Product Change Notification / ALAN-13SUCS155

CCB 4826 Final Notice: Qualification of TJS5 as an additional fabrication site for PD69208T4ILQ-TR-LE, PD81101ILQ-TR-LE, PD69204T4ILQ-TR-LE, and PD39208ILQ-TR-LE catalog part numbers (CPN) in 56L VQFN (8x8x1.0mm) package.

Implications of Adding TowerJazz 5 as Alternative Manufacture Site

Pre and Post Change Summary

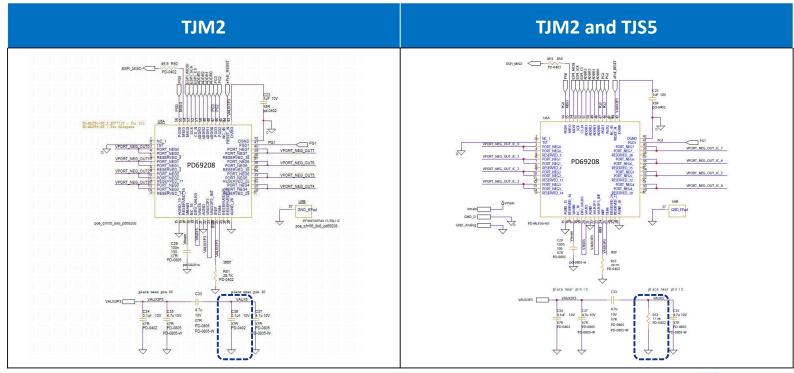
1	brication ocation	TowerJazz – Fab2 (TJM2)		TowerJazz – Fab2 (TJM2)			TowerJazz Panasonic Semiconductor Co., LTD. (TJS5)				
\ w	afer Size	8" inch		8" inch			8" inch				
	вом	0.1 μF	0.1 μF 0402 Capacitor (C36)		17.4 k	17.4 k Ω 0402 Resistor (R52)			17.4 k Ω 0402 Resistor (R52)		
	mponent				See pre and post change summary						
	ISO	ISO-9001 CERTIFIED	IATF16949 CERTIFIED	ISO-14001 CERTIFIED	ISO-9001 CERTIFIED	IATF16949 CERTIFIED	ISO-14001 CERTIFIED	ISO-9001 CERTIFIED	IATF16949 CERTIFIED	ISO-14001 CERTIFIED

With the introduction of the PD6920x and PD39208 TJ5 material, there is a minor change to the Application Schematic and BOM. Component C36 is changed from a 0.1 μ F capacitor to a 17.4 k Ω resistor. This resistor has a Reference Designator R52. This change is mandatory for TJ5 material and optional for TJ2 material. There is no performance degradation in making this change for TJ2 material. Either the 0.1 μ F capacitor or the 17.4 k Ω resistor can be used for TJ2 material with no detrimental effect.

C36 is a 0.1 μ F 10V X7R, 0402 capacitor. C36 is connected from the VAUX5 pin of the IC to analog ground. It will be replaced by R52 which is a 17.4 $k\Omega$ 1% 0402 resistor. As both components are 0402, R52 is a "drop in" replacement for C36. There is no critical implication on the PCB design or manufacturing process.

*Note: Same component footprint, no PCB change required.
